ACCESS REPORT

ISSUED FOR DEVELOPMENT APPLICATION

Newcastle Ocean Baths – Stage 2

230688-Access-r6

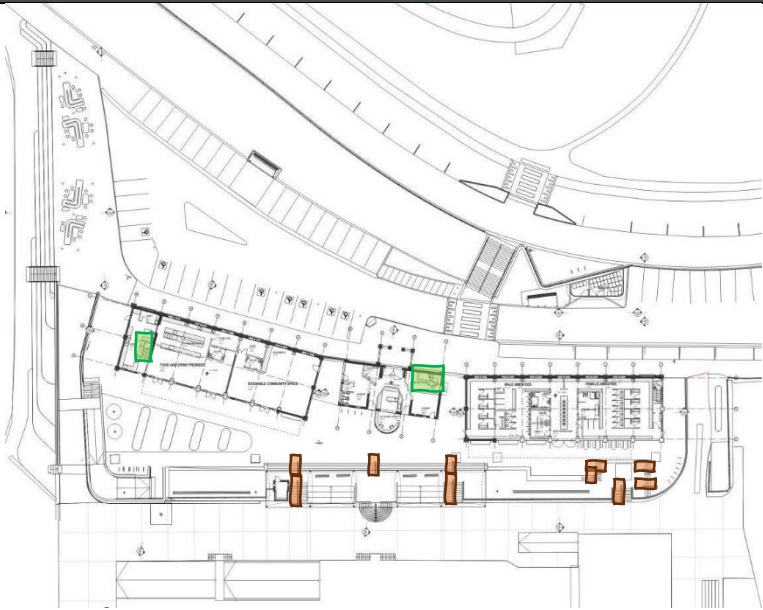
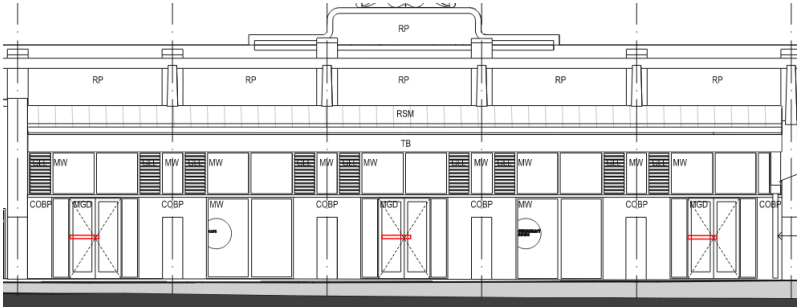
Item	Design Consideration	DtS Provision
1.	<u>Stairway and Handrail Construction</u> Stairways are to be provided with handrails on both sides, nosings and tactile ground surface indicators (TGSIs) in accordance with Clause 8 of AS 1428.1. Compliant handrails, including extensions and TGSIs have not been detailed to both sides of all stairways within the development, areas as described or shown below in both orange and green. ▪ Café stairway – handrail not shown on plans and does not have the spatial requirements to meet compliance for a two handrails, clearances and a distance of 1m between handrails. While a concession for no lift access is provided within the BCA, this does not exclude the requirement to provide a stairway with features to accommodate a range of disabilities other than wheelchair access. This may be considered by way of Performance Solution with the support of a plan of management. ▪ Training Room Stairway – handrails not shown on plans and do not have the spatial requirements for compliance for a handrail of consistent height through landings, and to provide the required circulation spaces at the ground floor. The stairway requires two handrails, clearances and a distance of 1m between handrails. This may be considered by way of Performance Solution and support of a plan of management. A feasibility study would be required. This may be considered by way of Performance Solution and support of a plan of management.	D4D4(a)

Item	Design Consideration	DtS Provision
	 Figure 6 Handrail locations Source: TZG Architects Given the design intent and use of the space where it is more advantageous to have wider stairways and larger circulation spaces, adjustments to some of the other handrails may be considered through a Performance Solution if required by the consent authority.	
2.	<u>Doors</u> The doorways are to have a minimum clear opening width of 850mm with a maximum of 20N force required to operate the door, measured through the active leaf only, below marked are a sample of doorways which do not currently meet the minimum requirements.  It is noted that the main entry doors to the Ocean Baths and amenities block are oversized and may require greater force than permitted.	D4D2 Clause 10.1, AS 1428.1 Clause 10.4.2, AS1428.1
